Office Action Summary

10/031,218

DETAILED ACTION

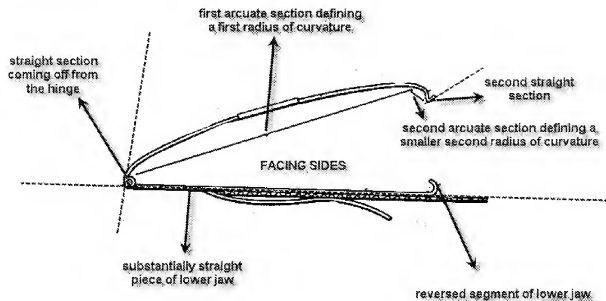
Ogden discloses a clip capable for use during surgery, as shown in the illustrated figure 4 below, the clip comprising:

said elongated upper jaw including, at the proximal end thereof, a first straight section supported for pivoting at the hinge pin (see figure below), and an arcuate shaped section contiguously adjoining the straight section and extending distally thereof and away from the hinge pin (see figure below);

said arcuate shaped section including a first arcuate shaped portion contiguous with said straight section and a second arcuate shaped portion contiguous with said first arcuate shaped portion disposed at an opposite end of said first arcuate shaped portion to said straight section (see figure below);

said elongated upper and lower jaws having respective facing surfaces (see figure below);

said first arcuate shaped portion having a first radius of curvature in its facing surface that is greater than a radius of curvature of said second arcuate shaped portion which has a second radius of curvature in its facing surface (see figure below);

wherein the first and second arcuate shaped portions are both defined in the facing surface of the upper jaw (see figure below);

wherein the first radius of curvature and the second radius of curvature are both defined by respective centers of curvature below the upper jaw (see figure below).

a second straight section (distal generally straight section having a free end) adjacent to said second arcuate shaped portion at the opposite end of said second arcuate shaped portion to the hinge pin, said second straight section, when in the closed position of the clip, interlocking under the latch of the lower jaw (see figure above);

wherein the total length of the first and second arcuate shaped portions is greater than the length of the straight section (see figure above);

wherein there is an absence of any straight portion or arcuate portion between said first and second arcuate shaped portions (see figure above);

wherein the first arcuate shaped portion is contiguous with the second arcuate shaped portion forming a complex contiguous curved shape (see figure above);

wherein said second arcuate shaped portion has an arcuate surface on both an outer contact surface thereof and an inner surface thereof (see figure above);
